A PROJECT AT
HOONAH, ALASKA
PROJECT SUMMARY
HOONAH
CITY FLOAT REPLACEMENT
& HARBOR EXPANSION

AS-BUILT
DATE COMPLETED: 9/7/07
CONTRACTOR: TRUCANO CONST.

Planset A
Hoonah City Float Replacement

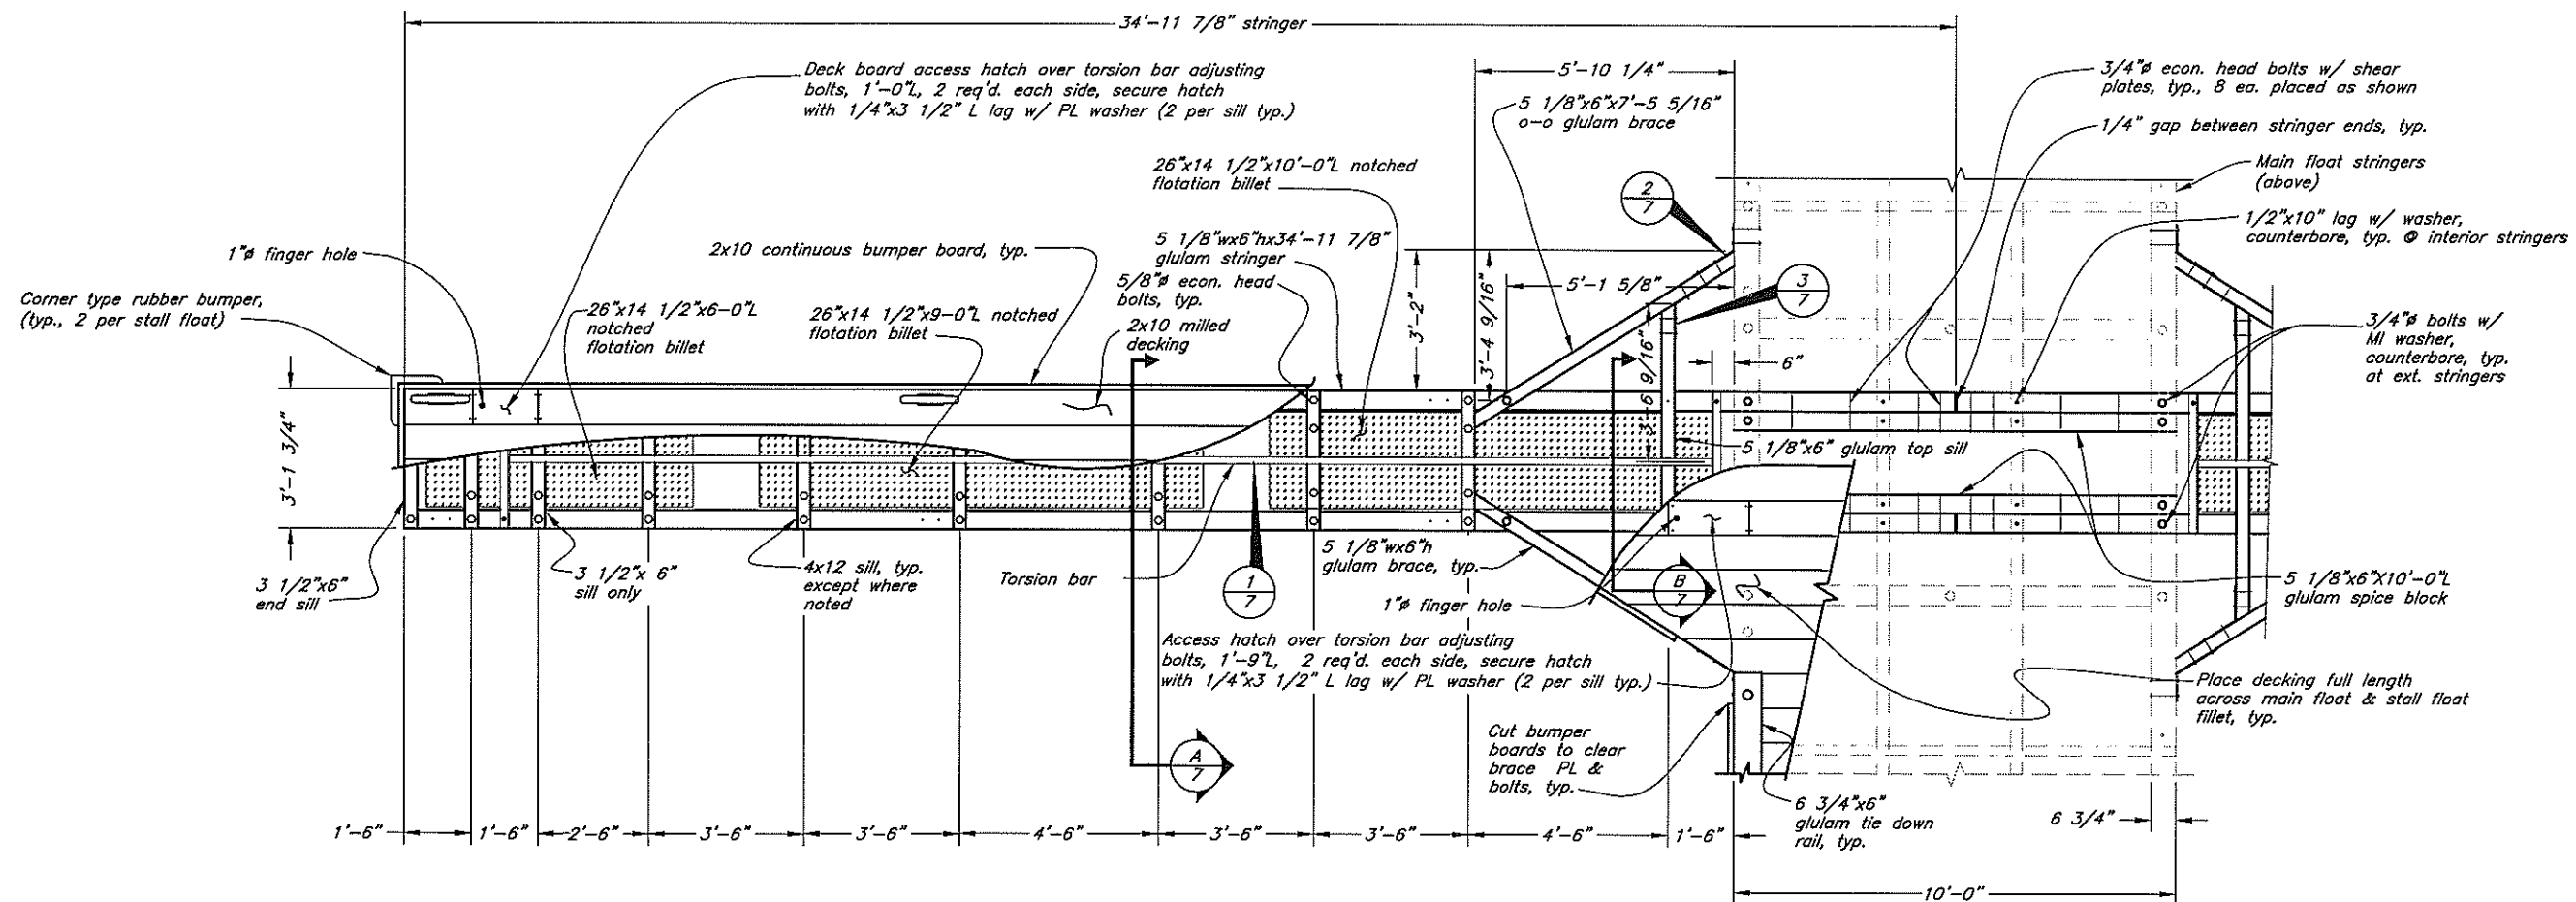
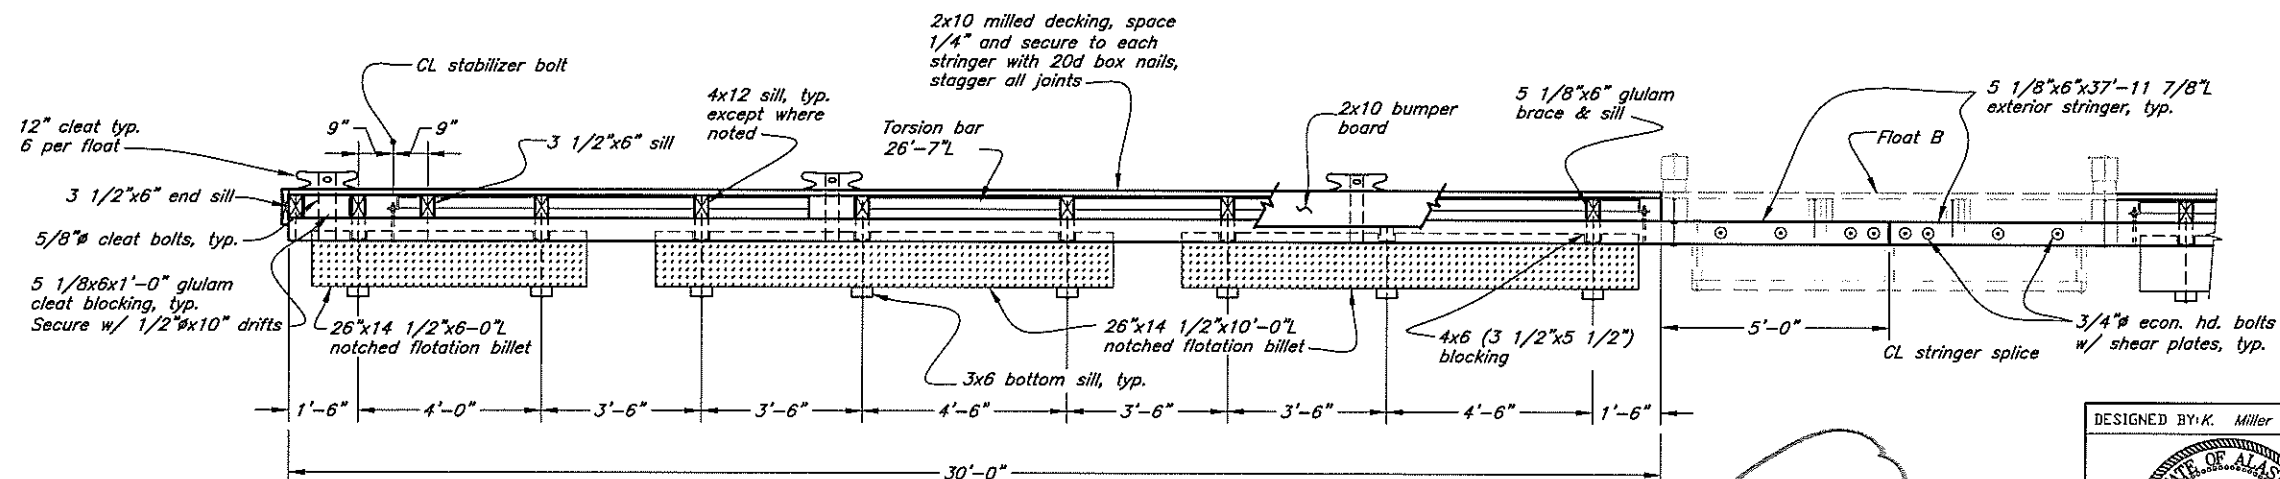
NOT
CONSTRUCTED

Pile Details

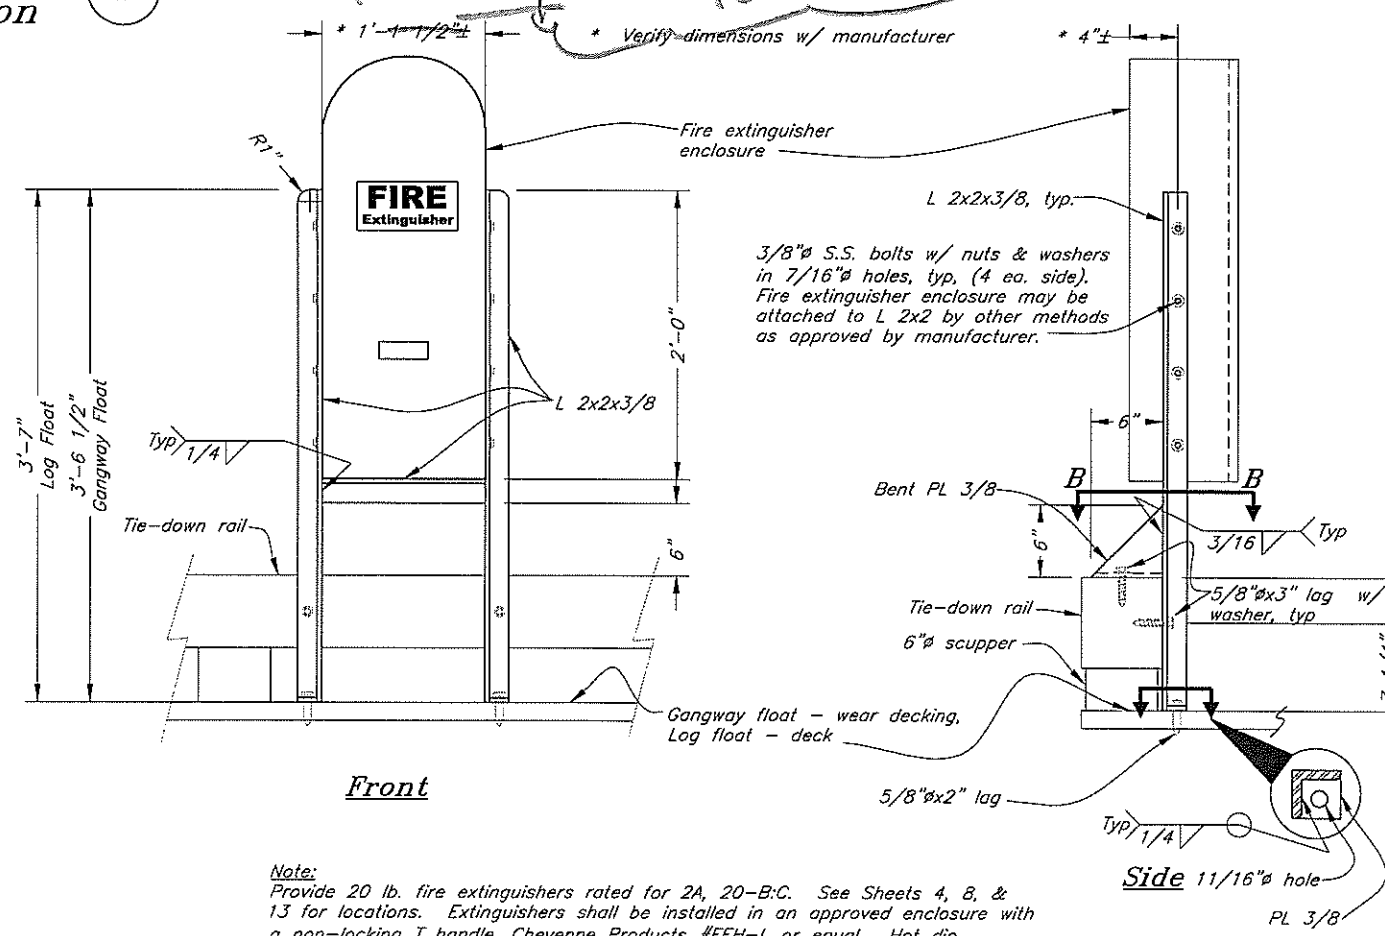
BOXES ARE 15/8" - DO NOT FIT! 4/5/07

FIELD WIDENED TO ~ 1'-2"

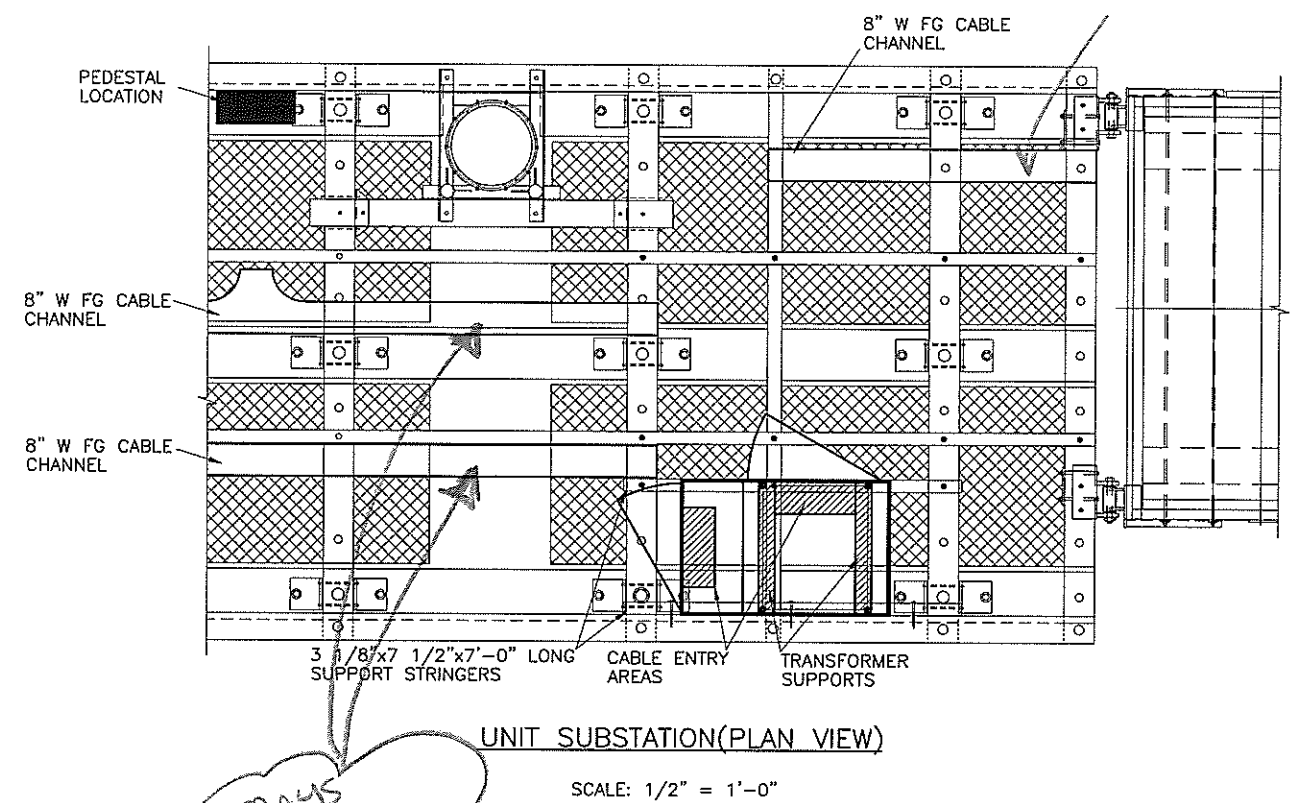
NOT CONSTRUCTED

TRAYS
EXTEND TO END
OF FLOAT
